From: Grayson, Terry L (DXT Services) [Terry.L.Grayson@contractor.conocophillips.com]
Sent: Tuesday, May 25, 2010 9:18 PM
To: Jakub, Barbara, Env. Health
Cc: Jan Wagoner
Subject: RE: SS# 5781 - Revised Site Plan & summary of proposed work (SB-8)

FIGURE 2
SITE MAP WITH CURRENT BORINGS, EXISTING WELLS, PROPOSED WELLS AND PROPOSED BORING
CONOCOPHILLIPS STATION NO. 5781
3535 PIERSON STREET
OAKLAND, CALIFORNIA

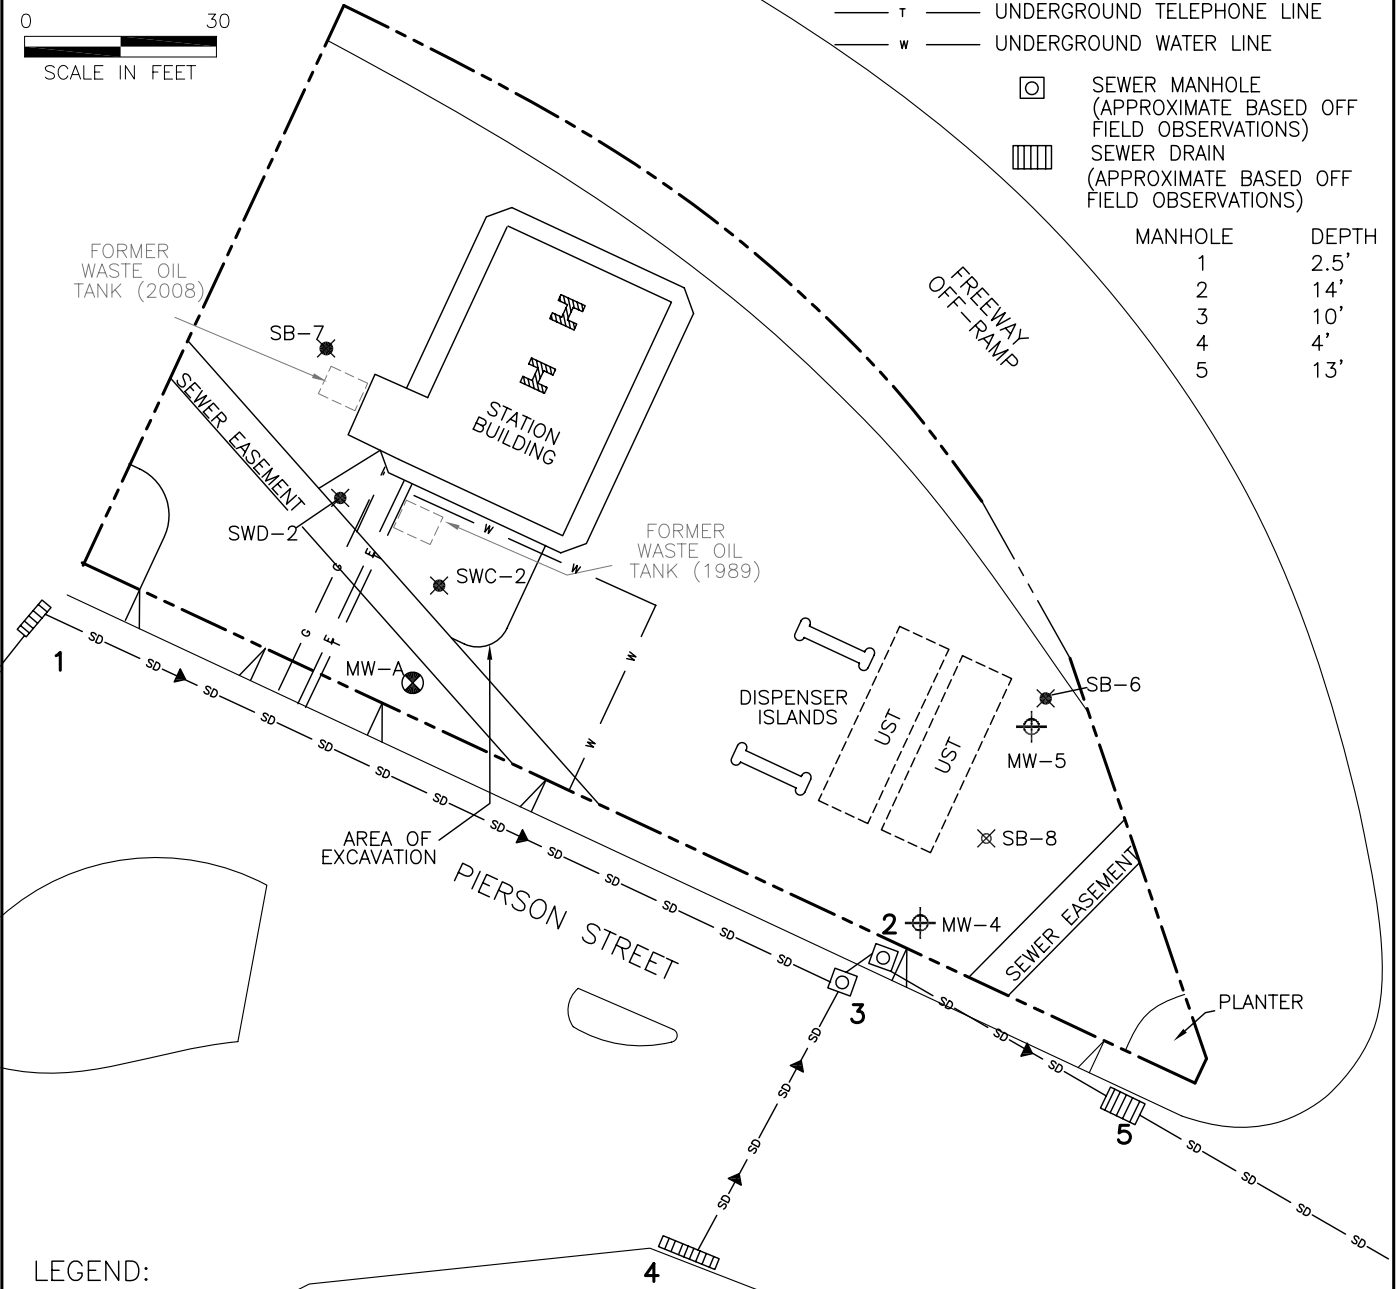
Your new proposal places one boring along a transect between the two proposed wells. This leaves the area between the waste-oil UST and gasoline USTs (on the south side of the dispensers) of the property unevaluated. Our concern is that the borings advanced between these two locations were advanced in 2003 and may not reflect current contamination levels. Placing an additional transect in this location would expedite characterization of the site.

Please ensure that soil samples are collected at the soil groundwater interface, changes in lithology, and at a minimum of every five feet.

I appreciate your comments and concerns however we believe that placing SB-8 where shown will give a solid representation of any concerns between the two proposed wells also etc..

Also SB-7 recently done was completely clean and we therefore believe that the area in concern between the building and the canopy to also be still clean.

For now given the lack of time and resources we will continue as shown on Figure 2 with the work to be completed by the end of day next Friday the 4th.
